INSTRUMENT READINESS REVIEW

NSLS-II 18-ID FULL FIELD X-RAY IMAGING (FXI) BEAMLINE AND FRONT END

October 25, 2017

NSLSII-18ID-RPT-003

Figure 1: Hard stops for collimating mirror shown with arrows.

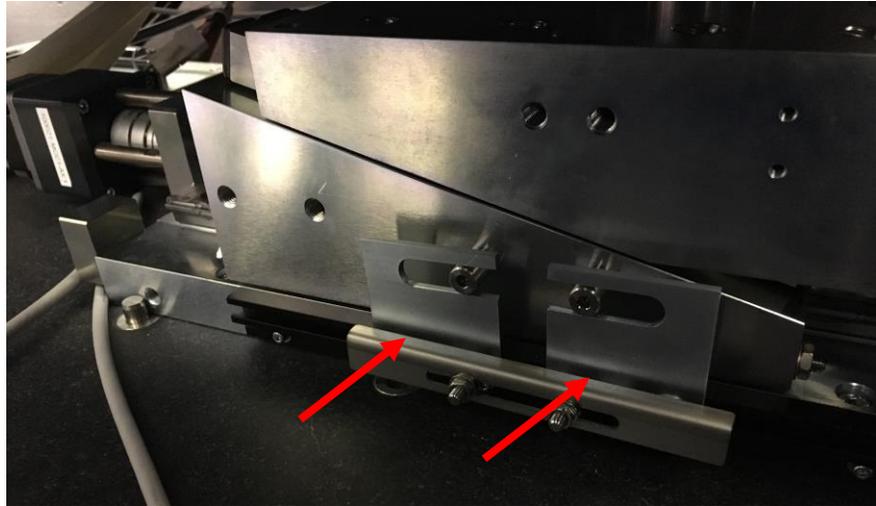
- 2.2.1.3. **Pre-Start 3 Condition:** The collimator mirror in the FOE is a radiation safety component whose motion is required to be constrained by a pair of hard stops (see Fig. 1). Analysis of the radiation safety considerations assume that the motion of the mirror will be fully constrained by the hard stops and no further analysis of the potential missteering due to failure of the hard stops to constrain the motion of the mirror was completed. Furthermore, no engineering analysis of the ability of the hard stops to constrain the motion of the mirror was produced by NSLS-II despite concerns by the team that the hard stops did not appear to be adequately robust and might shift in a manner that would not be immediately apparent, leading to potential beam missteers that lie outside of the scope of the present analysis.

- **Pre-Start 3 Finding:** Because the collimator mirror has been declared to be a radiation-safety component, the present constraints on the motion of the mirror are not sufficient for safe operation. After review by the IRR team, the commissioning plan (NSLSII-18ID-PLN-004) was modified by the lead beamline scientist to provide for

constraints on the commissioning activities and the motion of the mirror based on the beam current delivered to the beamline.

The team has no pre-start finding for the proposed mode of operation as outlined in the commissioning plan. **However**, to operate outside of the constraints outlined in the commissioning plan, specifically, *NSLSII-18ID-PLN-004, Rev. 2, 24 October 2017*, **will require further evaluation by this IRR team.**
